SUBMISSION TO DA2019/0391 – 25 LOCH STREET, FRESHWATER

This submission has been prepared on behalf of the owners and occupiers of 23 Loch Street Freshwater, in relation to Development Application DA2019/391 for the demolition of the existing dwelling and construction of a new three storey dwelling on the site at 25 Loch Street, Freshwater. The owners of 23 Loch Street appreciate the consultation that has been undertaken in relation to the proposal, however the design changes requested which have the ability to improve amenity outcomes have not been adopted.

ACN: 146 035 707 ABN: 54 146 035 707
Suite 4, Level 7, 100 Walker Street
North Sydney NSW 2060
P: 02 9929 6974
enquiries@willowtreeplanning.com.au
www.willowtreeplanning.com.au

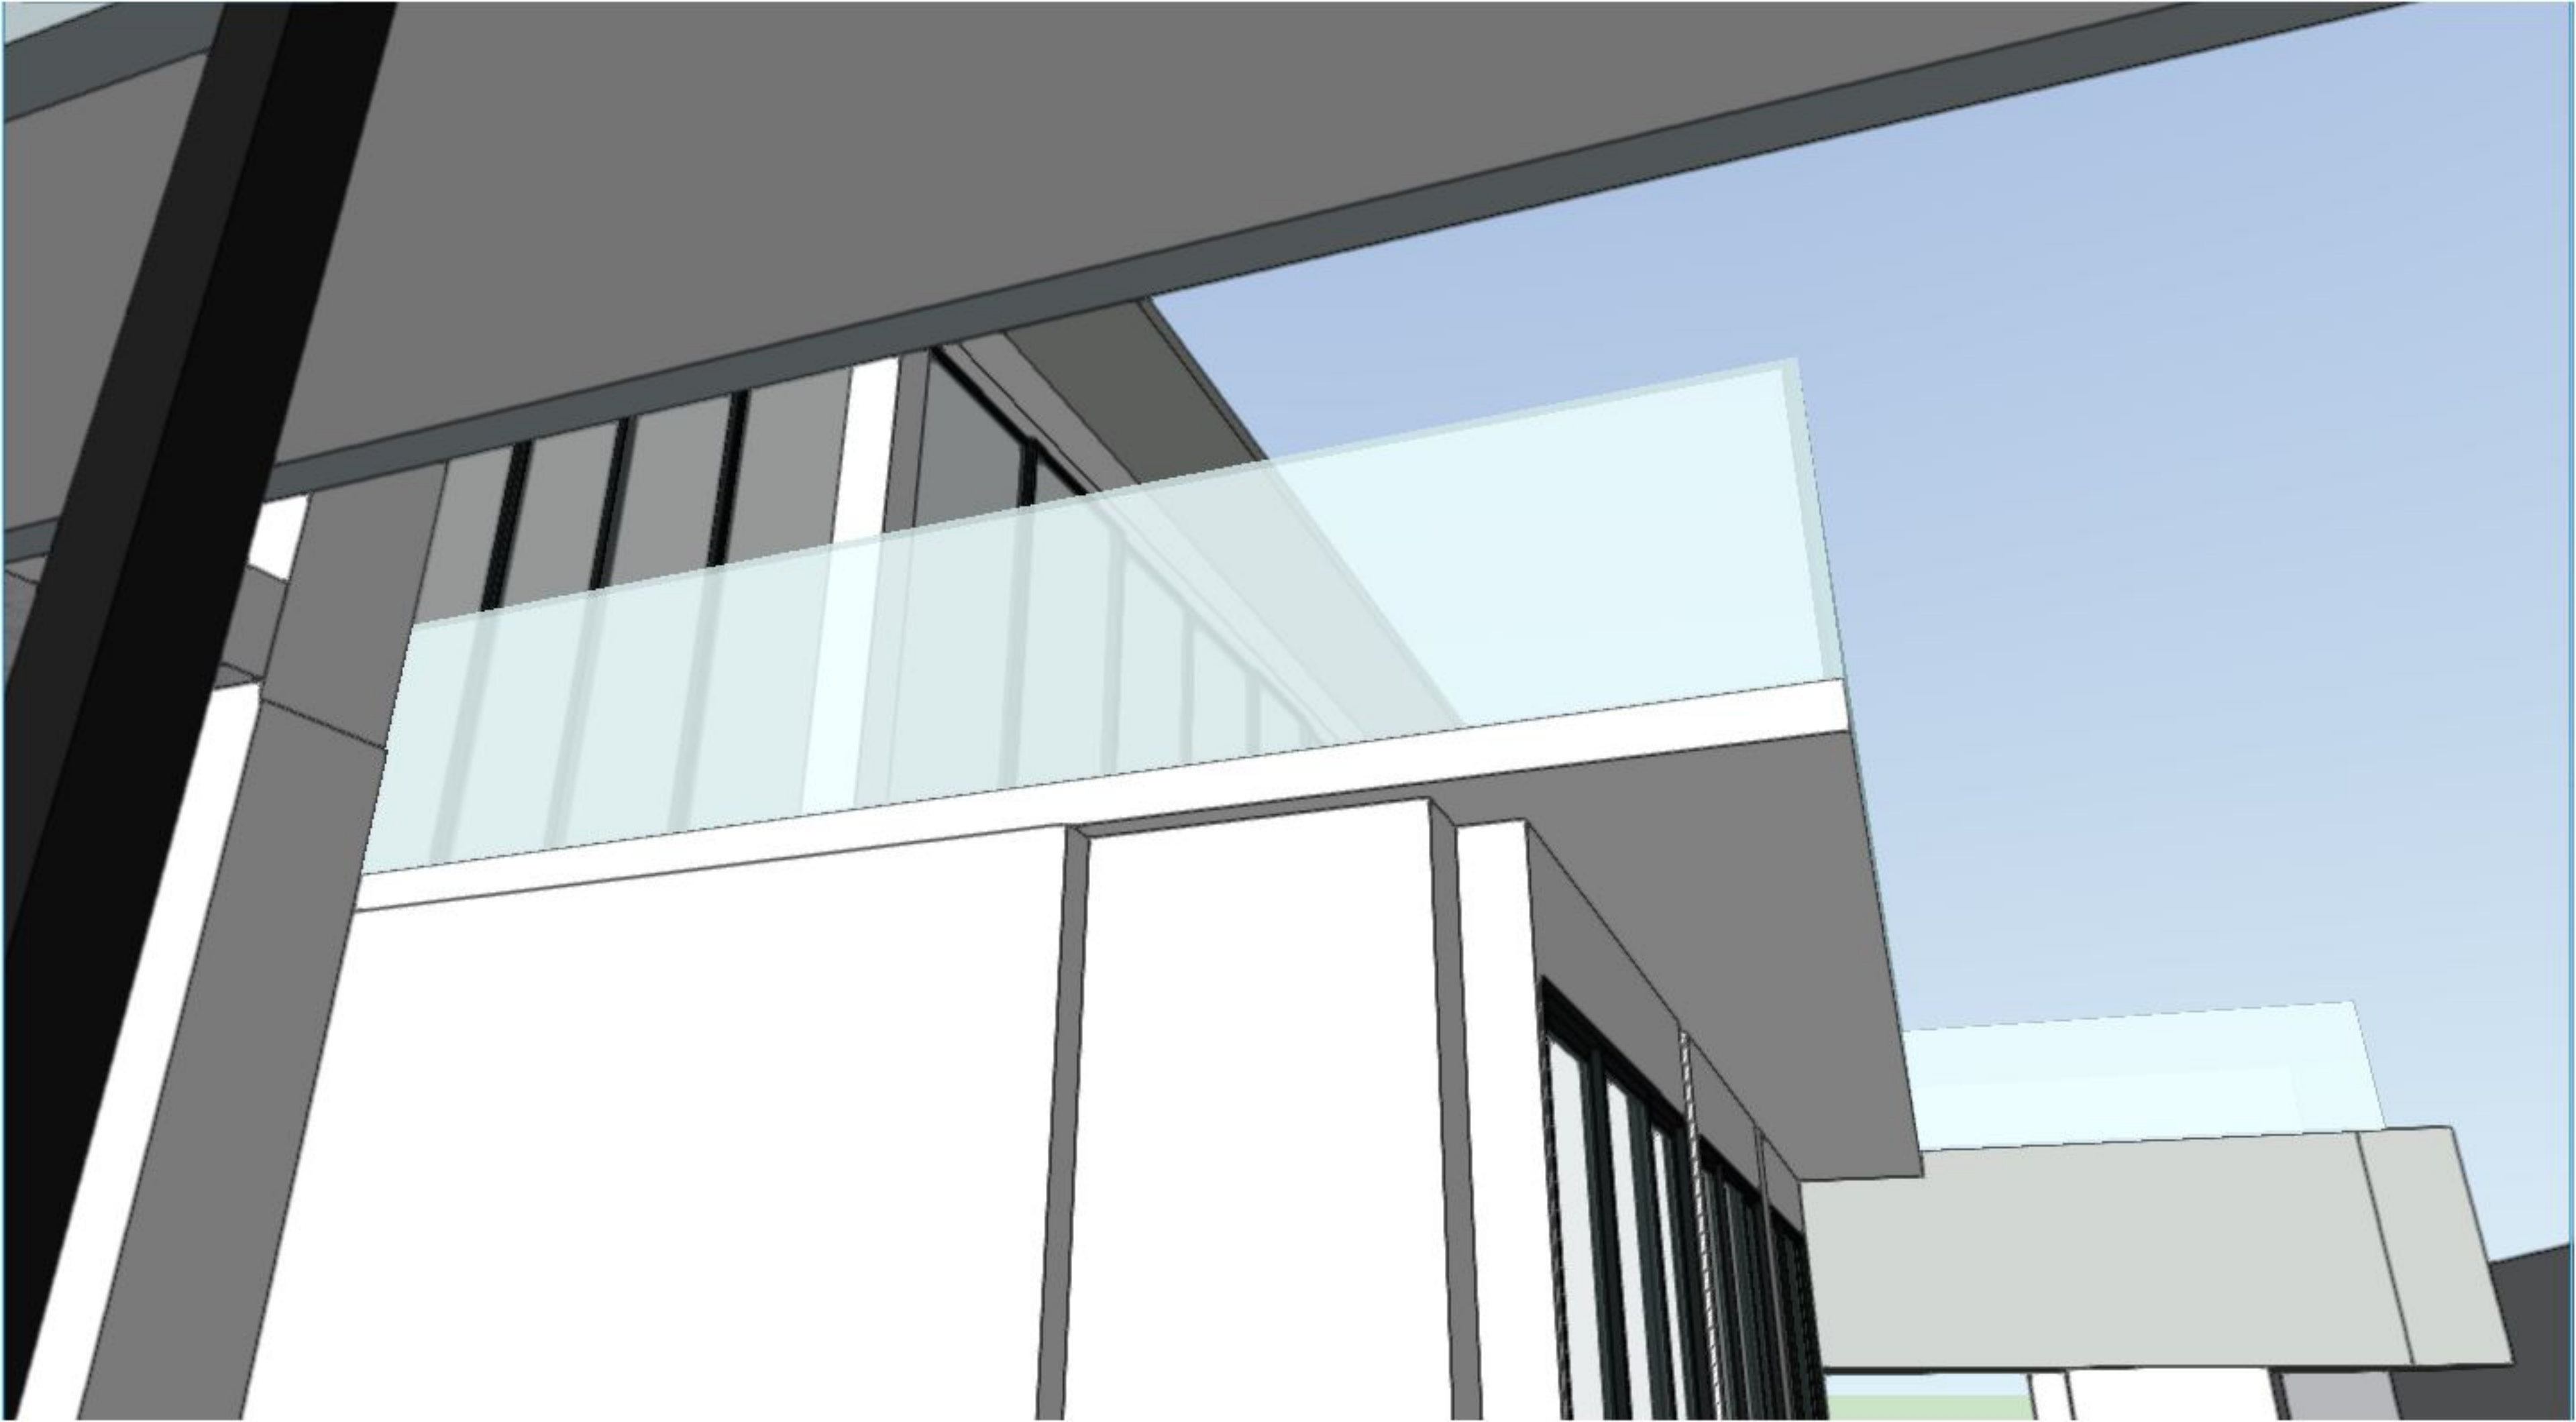
WDCP 2011 (B1) requires that walls are not to exceed 7.2m in height as measured vertically from ground level (existing) to the underside of the ceiling on the uppermost floor of the building. The independent analysis prepared shows that there is a portion of the mid-level and upper floor which does not comply. The proposal should be amended to eliminate this non-compliance as it contributes to the overbearing nature of the development (refer **Appendix 1**).

Images prepared by the Architects for 23 Loch Street show the extent of overlooking that would result and confirm that additional design measures are required to mitigate impacts (refer **Appendix 1**).
